# SERVICE BULLETIN

NON-MODIFICATION SERVICE BULLETIN — REPLACEMENT OF NO. 3 BEARINGS  
FROM SUSPECT POPULATION (LOT A)

V2522-A5, V2524-A5, V2527-A5, V2527E-A5, V2527M-A5, V2530-A5, V2533-A5

# V2500-ENG-72-0673

LOCATION OF THE NO. 3 BEARING  
FIGURE 1

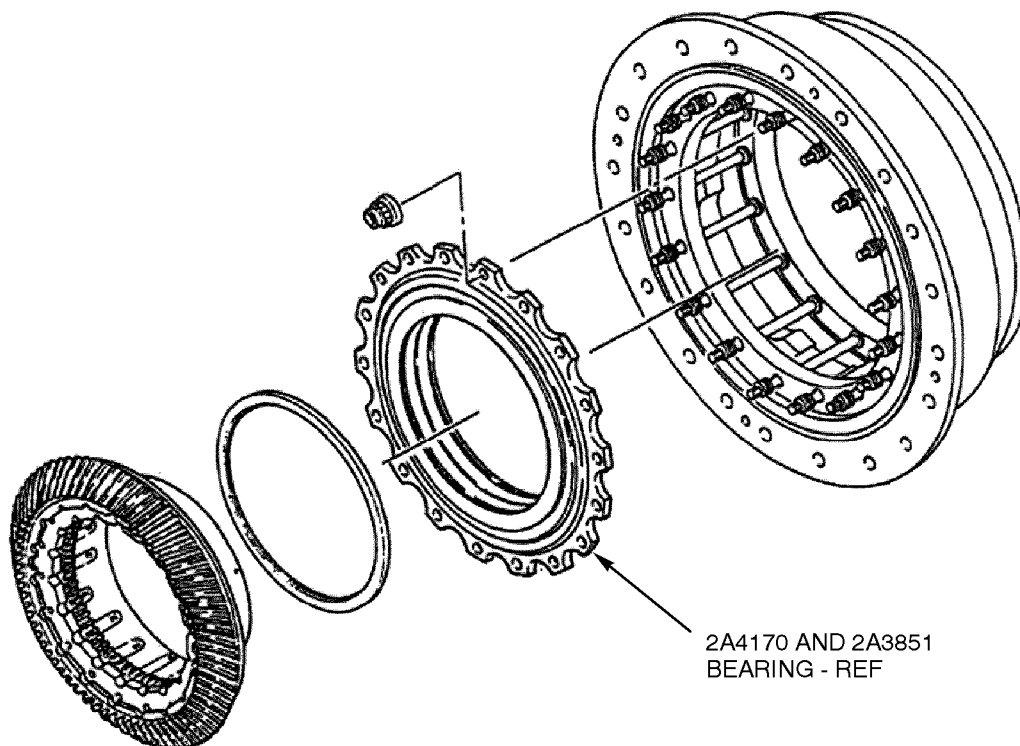
Remove and replace the No. 3 Bearing listed in Table 1 and Table 2 of the Accomplishment Instructions.

2. Replace suspect No. 3 Bearing with No. 3 Bearing Option, PN 2A4235:
  - A. Install a new No. 3 Bearing. Refer to Reference 4, EM, TASK 72-32-24, 01-100.
